ADDENDUM NO. 2

January 19, 2023

DUNELAND BRUMMITT ELEMENTARY SCHOOL RENOVATIONS Chesterton, IN 46304

Addendum Two (AD.02) to the drawings and specifications prepared by Gibraltar Design for **Brummitt Elementary School Renovations** for Duneland School Corporation, Chesterton, Indiana.

BUILDING ELEVATIONS

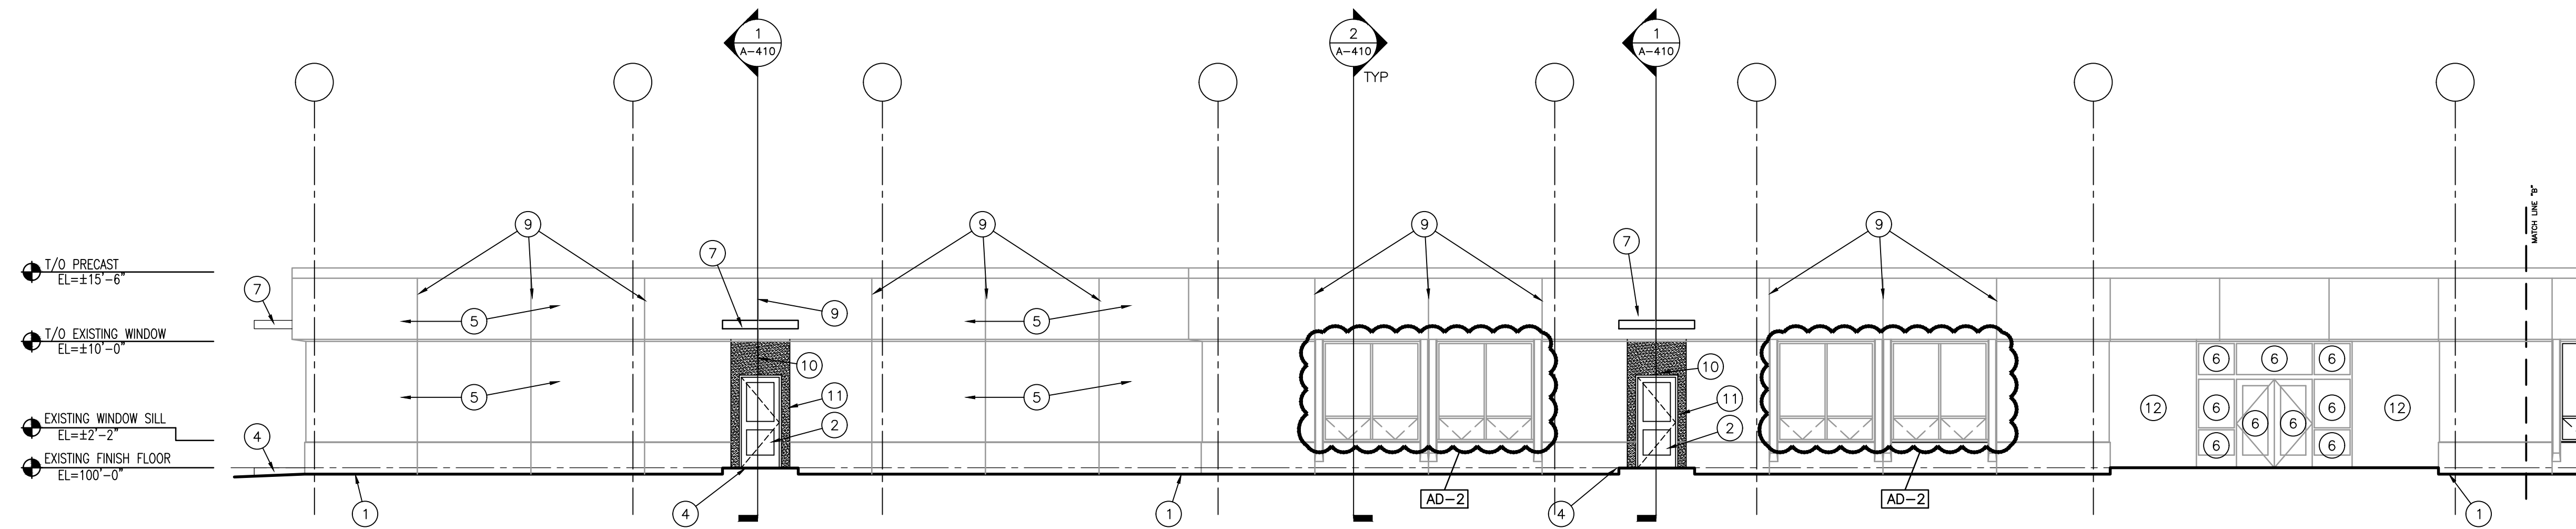
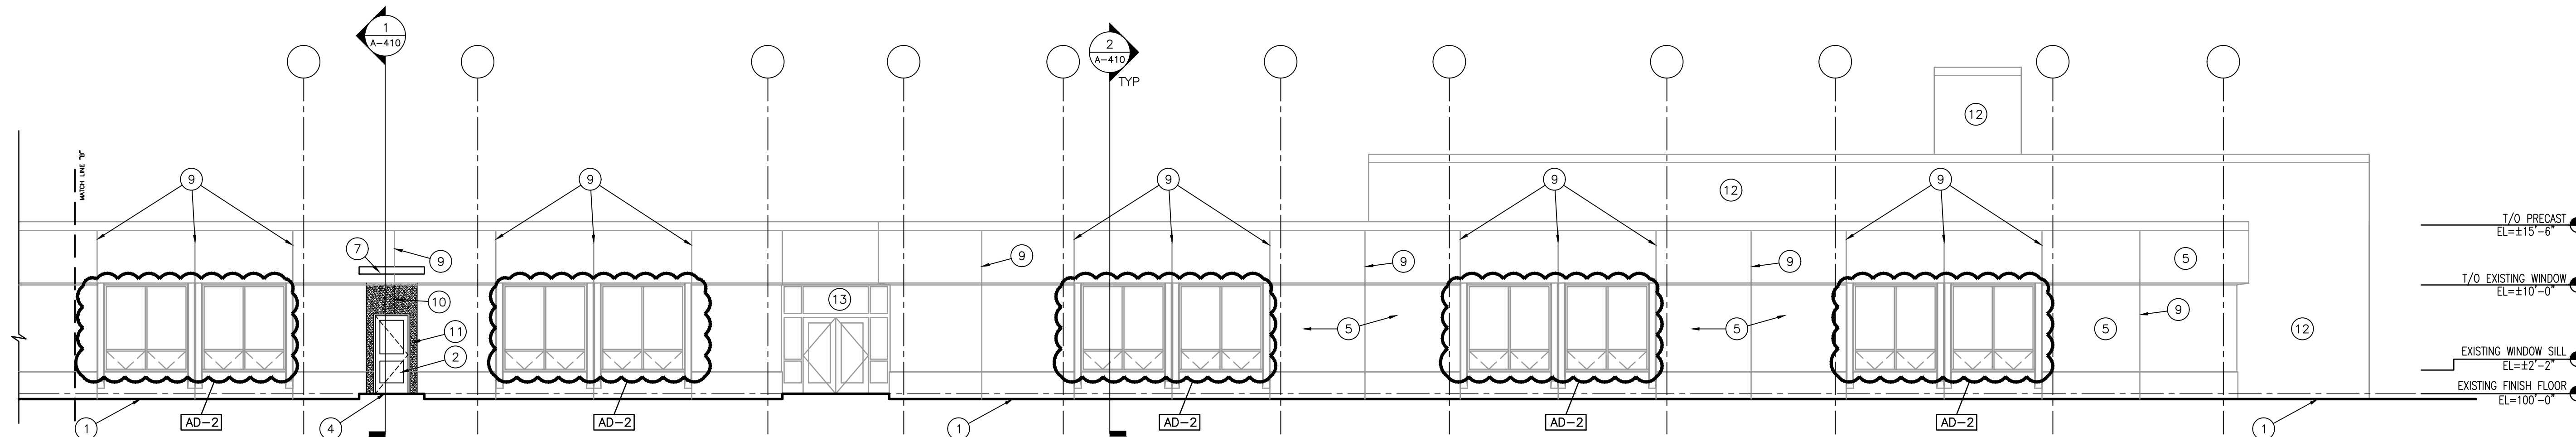
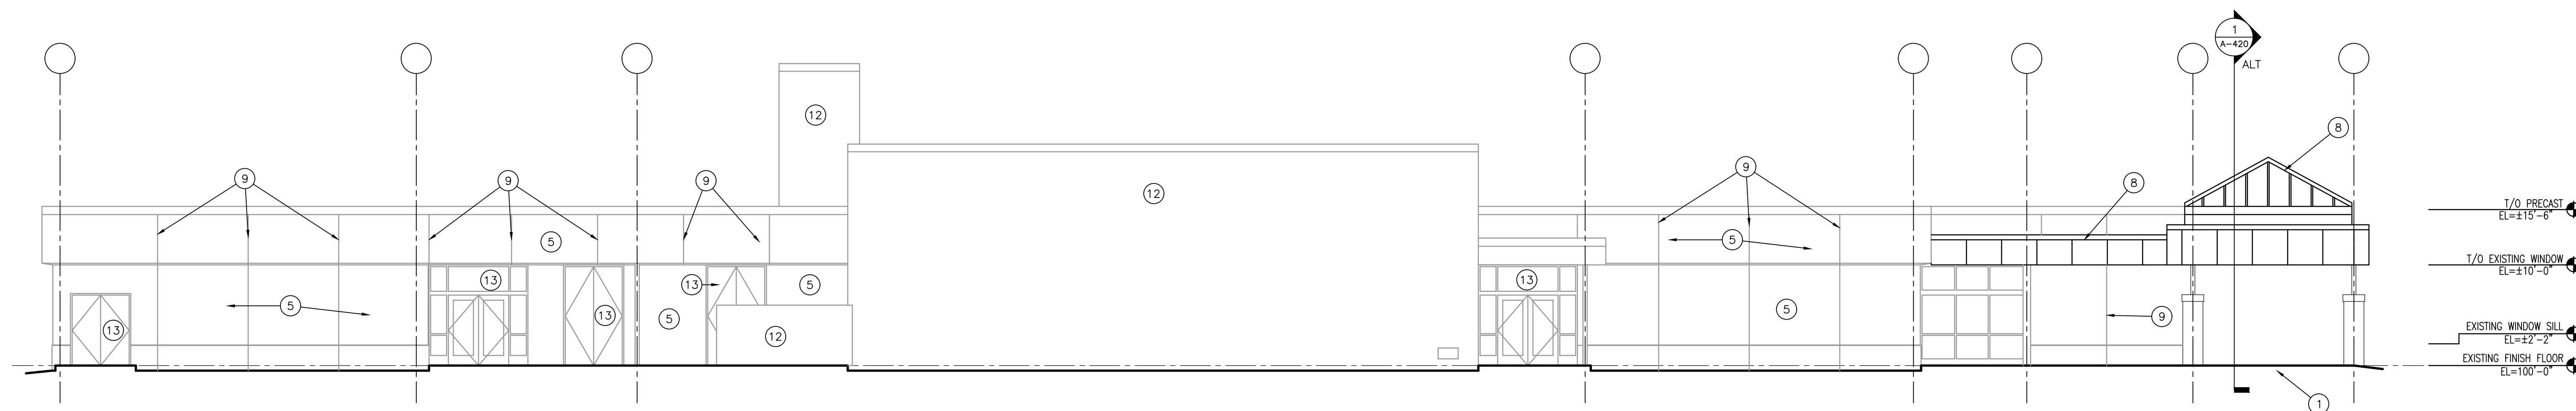
- A. Refer to two (2) revised full size drawings, included in this Addendum, for the following revisions:
1. Change Elevation Key Note 3 to read "Not Used."
 2. Change new exterior windows to existing to remain and remove W1 tag and keynote 3 at each window.
 3. Change exterior main entry storefront to new and change associated keynote from 13 to 2.

A-730

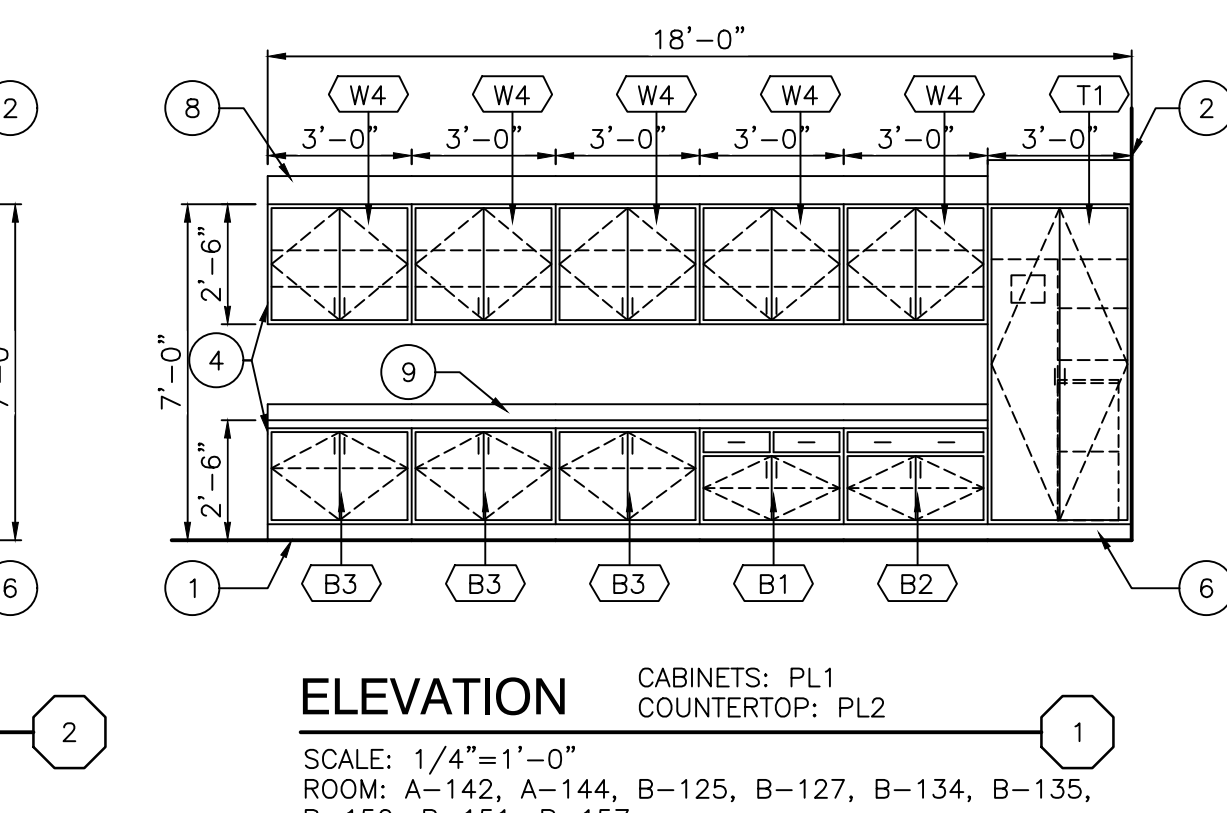
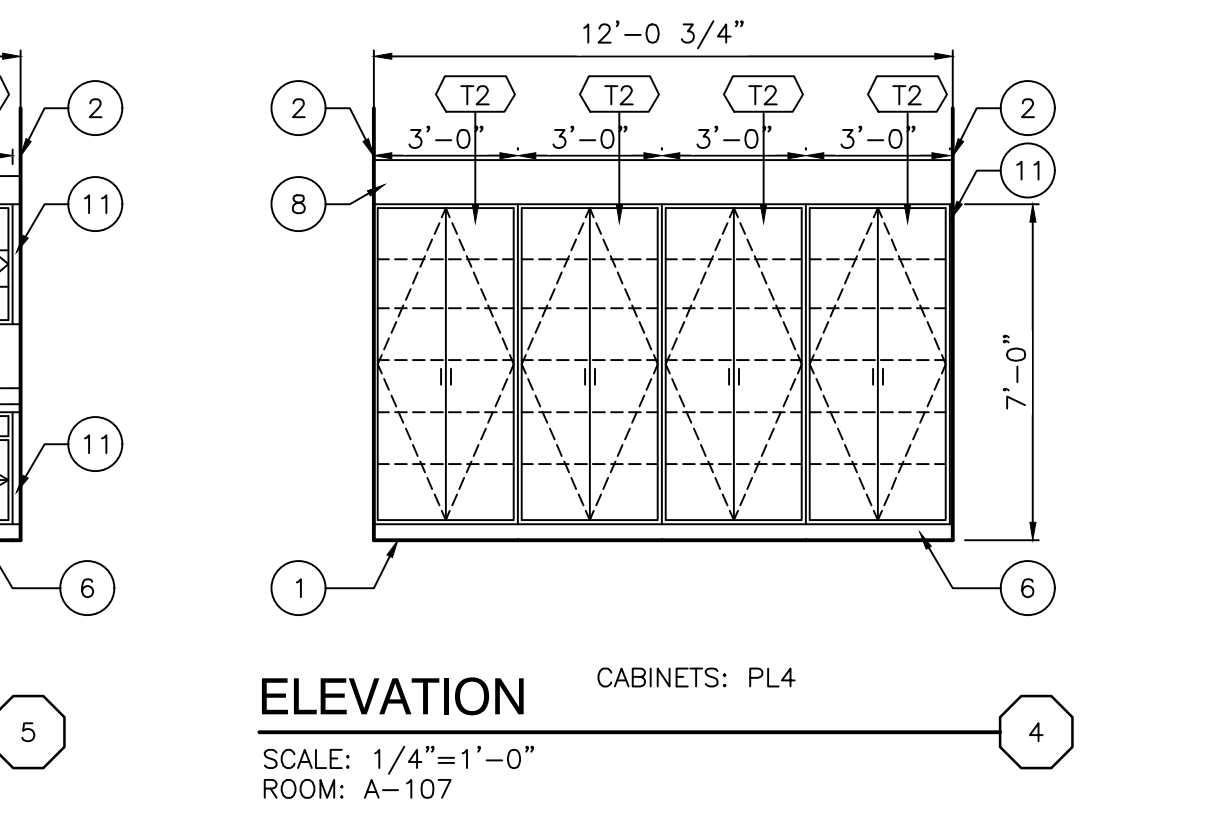
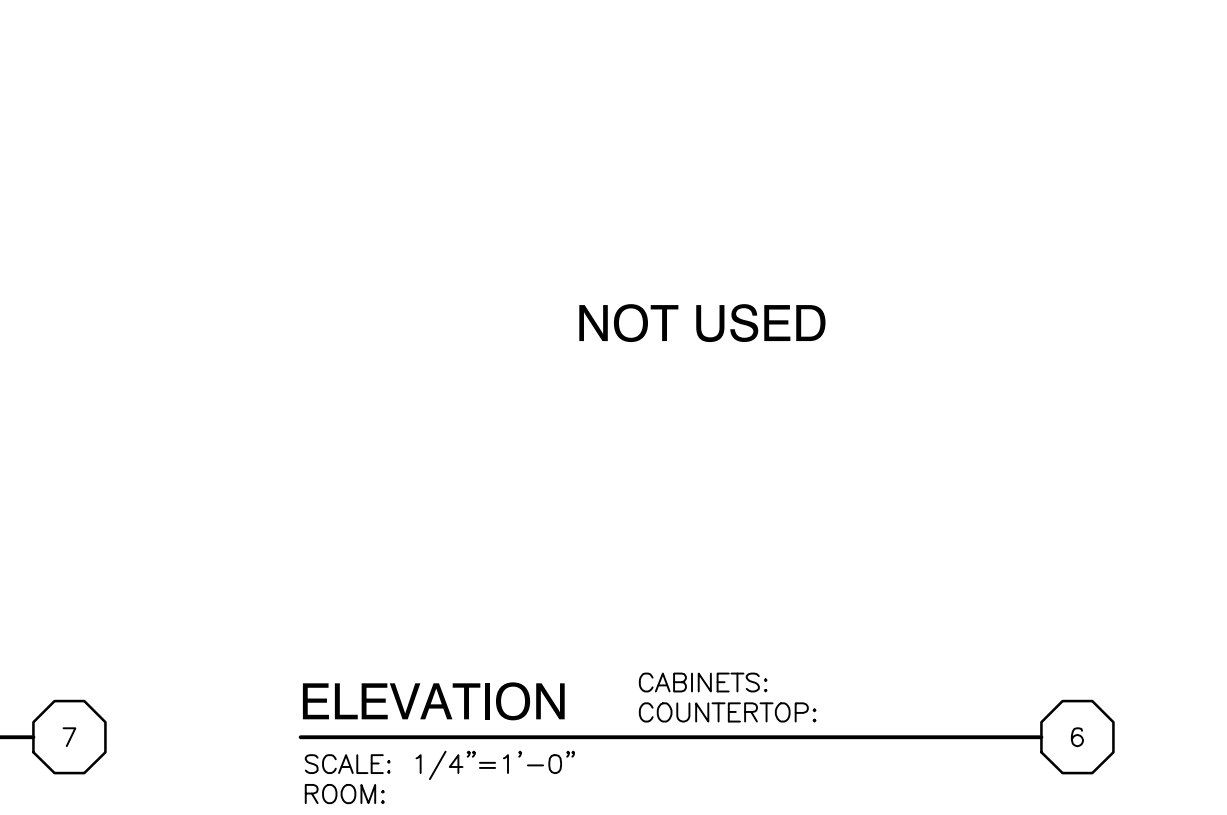
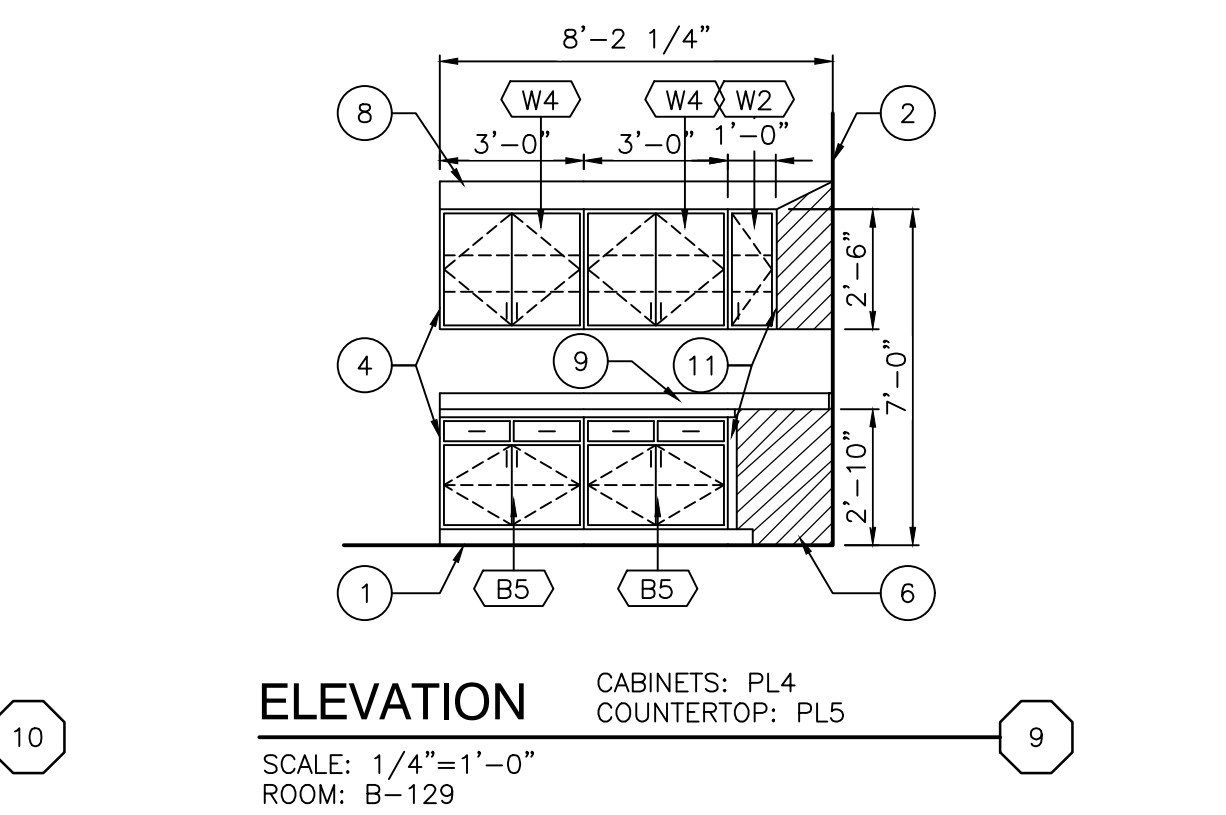
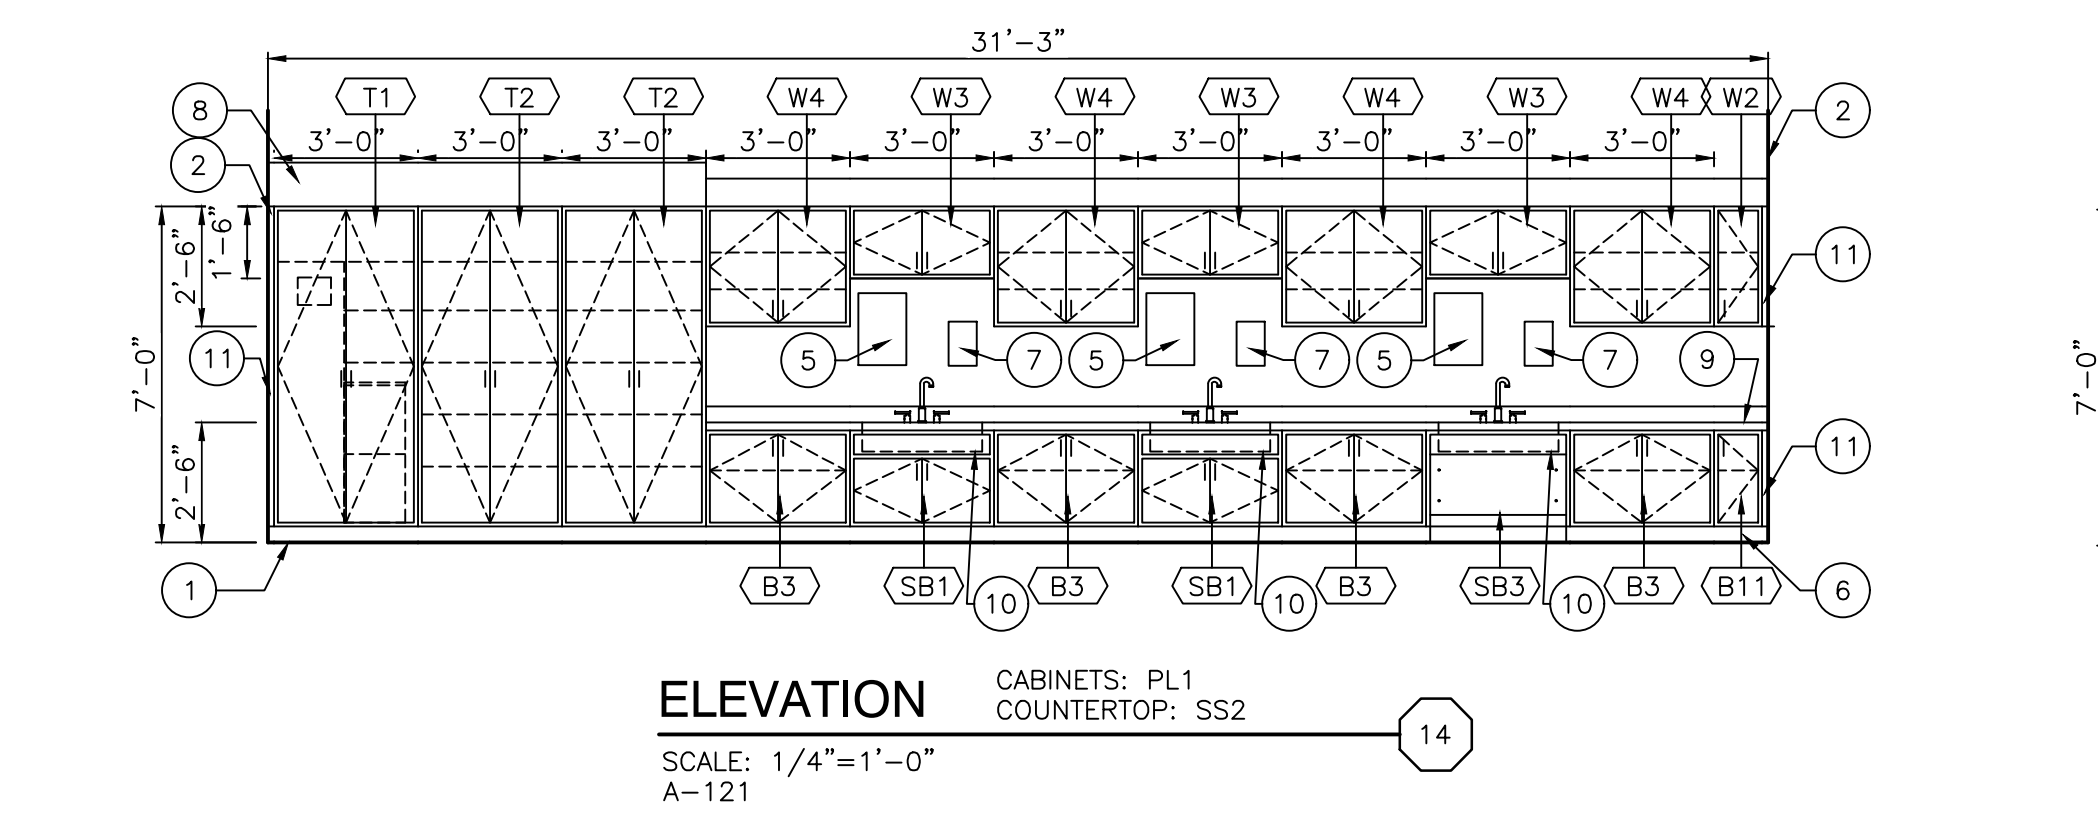
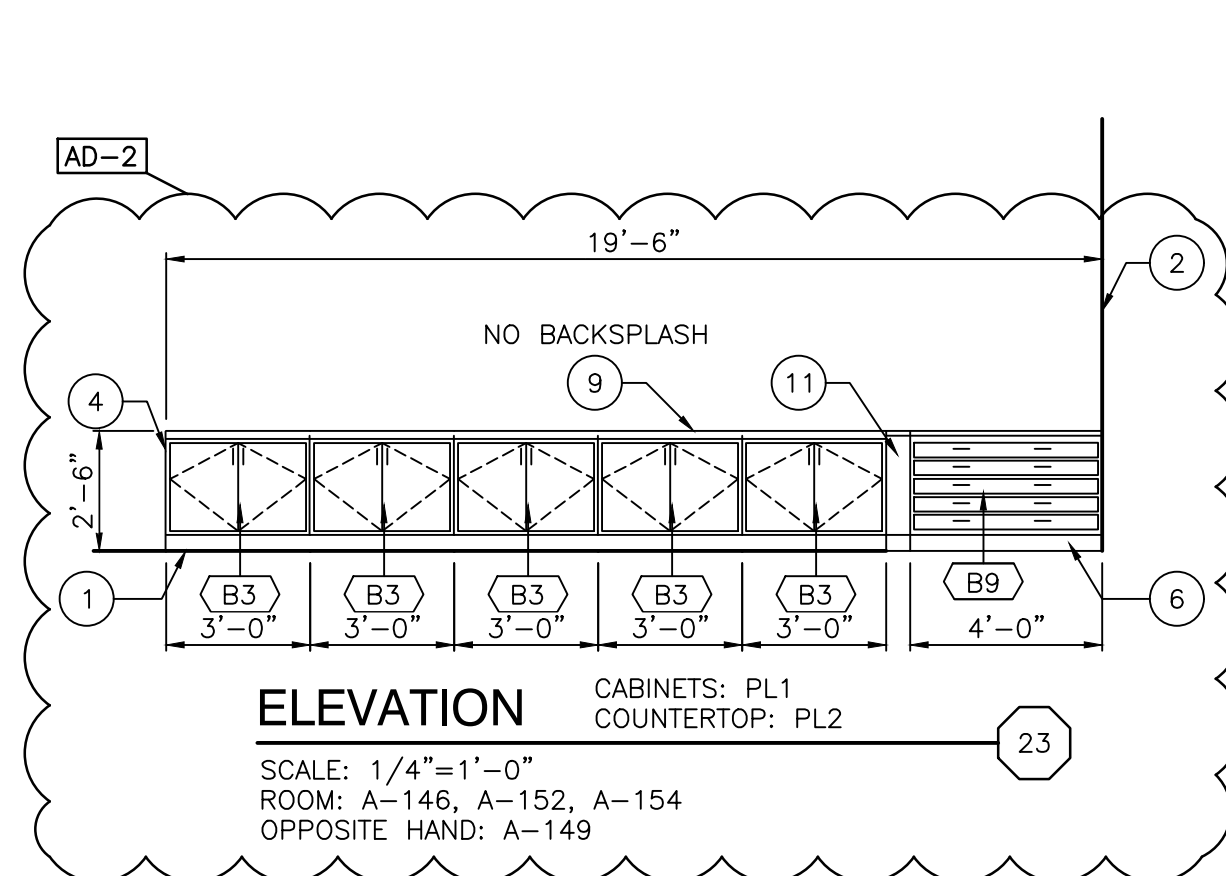
- A. Refer to revised full size drawing, included in this Addendum, for casework change in Elevation 23.
